Subject: MIL ON WITH DTC P0106	Bulletin No: 01-044/06
	Last Issued: 11/7/2006

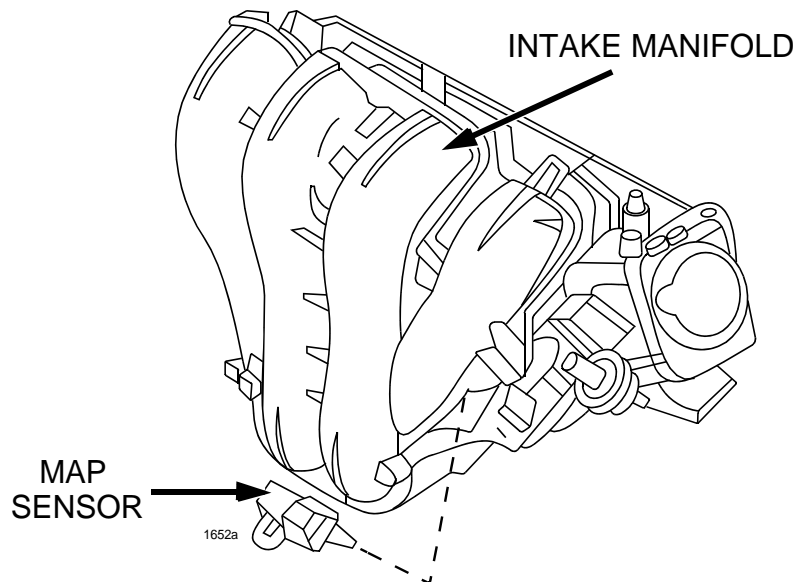
On some vehicles, the MIL may come on with DTC P0106 (MAP sensor malfunction) stored in memory due to corrosion of the MAP sensor chip. This produces a short circuit which causes the output characteristics of the MAP sensor to fall out of specification.

1. Verify customer concern.
2. Replace the MAP sensor with a modified one.

Part Number	Description	Qty.
L301-18-211B	Pressure Sensor	1
